Errata to **MCF5206e ColdFire Microprocessor** **User's Manual, rev. 3.0**

This errata describes corrections to the *MCF5206e User's Manual*. For convenience, the section number and page number of the errata item in the user's manual are provided.

Figure 1. Longword Write Transfer from a 32-Bit Port (Address Setup, No Wait State, No Address Hold)

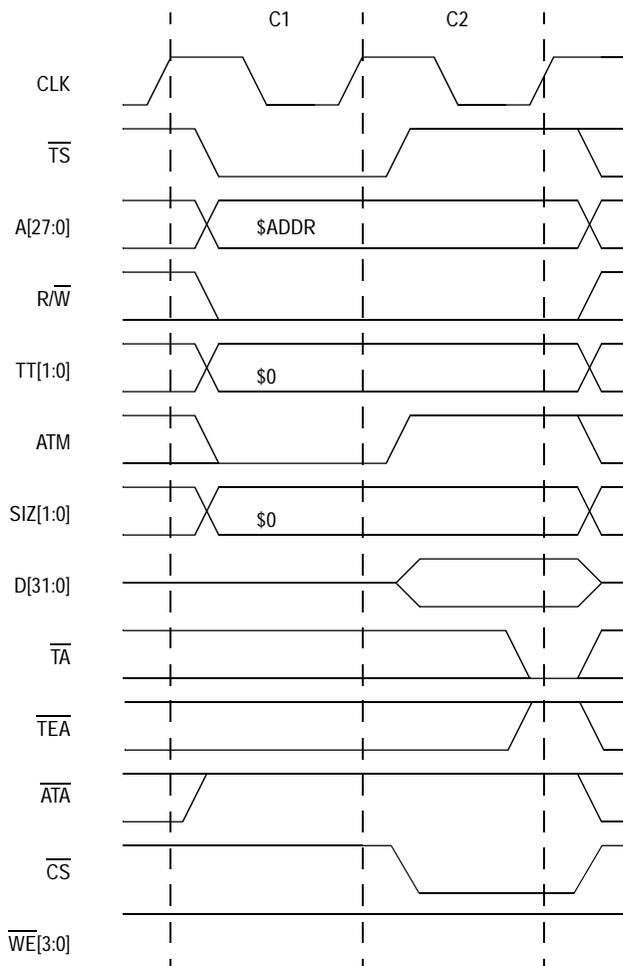
9.3.3.1, 9-9 Add the following paragraphs.

9.3.3.1a Nonburst Transfer with Address Setup, No Address Hold, No Wait State.

The write cycle starts in C1. During C1, the MCF5206e places valid values on the address bus (A[27:0]) and transfer control signals. The transfer type (TT[1:0]) signals identify the specific access type and access type and mode (ATM) is driven low to identify the transfer as data. The read/write (R/W) signal is driven low for a write cycle, and the size signals (SIZ[1:0]) are driven low to indicate a longword transfer. The MCF5206e asserts transfer start (TS) to indicate the beginning of a bus cycle. Note WE[3:0] are never asserted.

During C2, the MCF5206e asserts the appropriate chip select (\overline{CS}) for the address being accessed, negates transfer start (\overline{TS}), drives access type and mode (ATM) high to identify the transfer as supervisor, and drives data onto D[31:0]. If the selected device(s) is ready to latch the data, it latches D[31:0] and asserts the transfer acknowledge (\overline{TA}). At the end of C2, the MCF5206e samples the level of \overline{TA} . If \overline{TA} is asserted, the transfer of the longword is complete, and the MCF5206e negates \overline{CS} after the next rising edge of CLK. If \overline{TA} is negated, the MCF5206e continues to sample \overline{TA} and inserts wait states instead of terminating the transfer. The MCF5206e continues to sample \overline{TA} on successive rising edge of CLK until it is asserted. If the bus monitor timer is enabled and \overline{TA} is not asserted before the programmed bus monitor time is reached, the cycle is terminated with an internal bus error.

Figure 16-3 shows pin values recommended for disabling JTAG with the MCF5206e in JTAG mode (MTMOD=0).

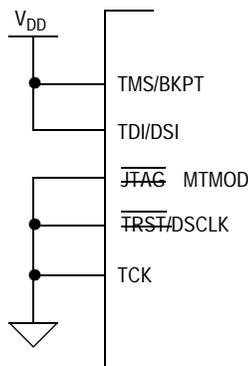
Modify the last sentence of the second paragraph and Figure 16-3 so they appear as follows:

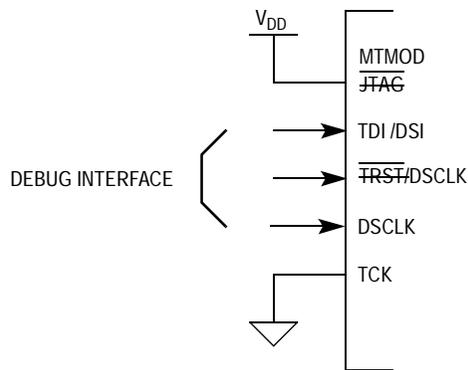
Strike out the references to $\overline{\text{TRST}}$ in the excerpt from the second paragraph shown below so that it reads as follows:

... This requires the minimum of either connecting the $\overline{\text{TRST}}$ pin to logic 0, or connecting the TCK clock pin to a clock source that will supply five rising edges and the falling edge after the fifth rising edge, to ensure that the part enters the test-logic-reset state. ~~The recommended solution is to connect $\overline{\text{TRST}}$ to logic 0.~~ Another consideration is that the TCK pin does not have an internal pull-up as is required on the TMS, TDI, and $\overline{\text{TRST}}$ pins; therefore, it should not be left unterminated to preclude mid-level input values.

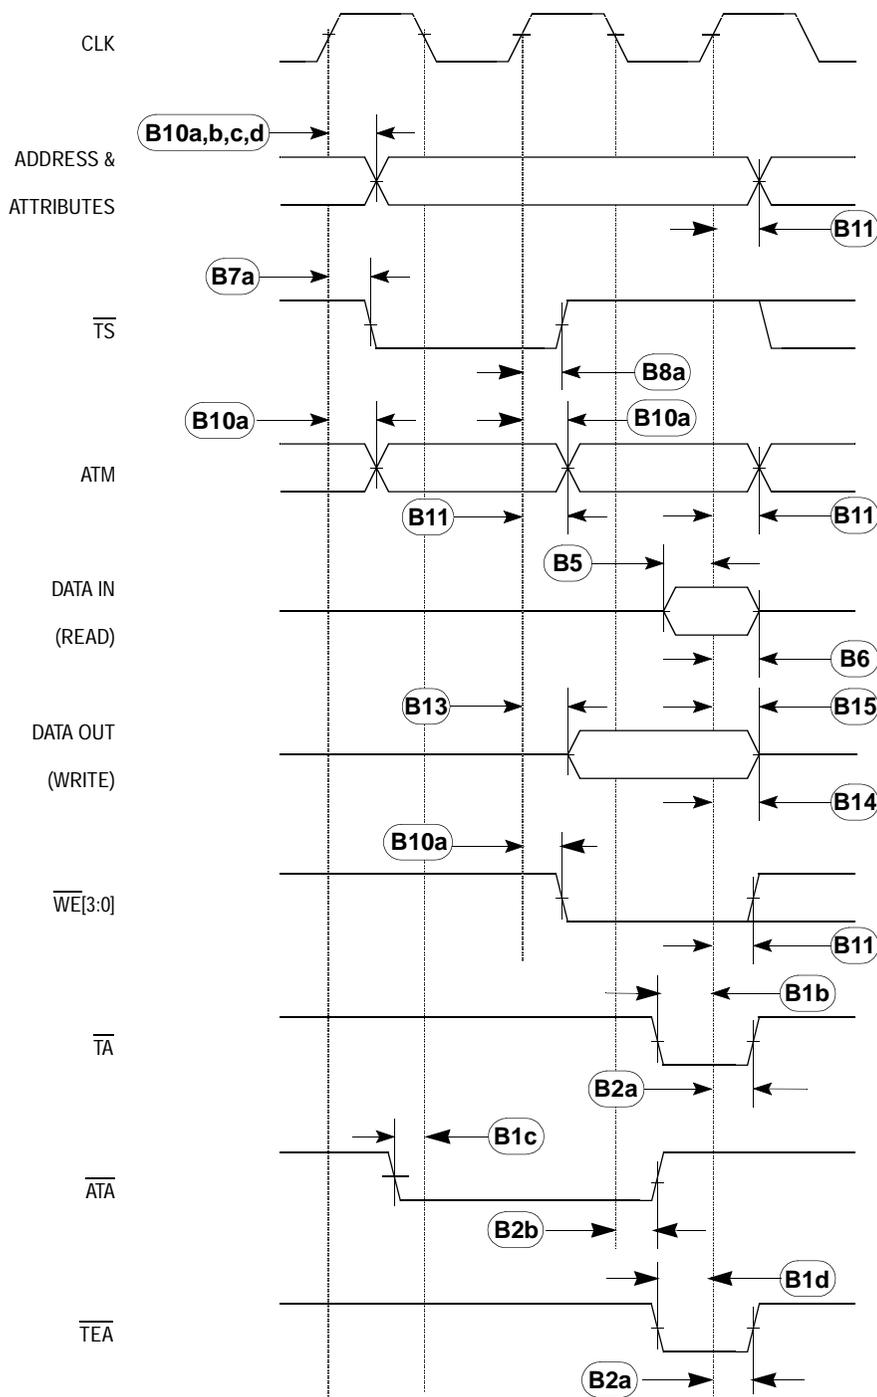
In Table 17-8, change the Min specification for B5 to 7.0 ns for the 40 MHz device and 3.5 ns for the 54 MHz device.
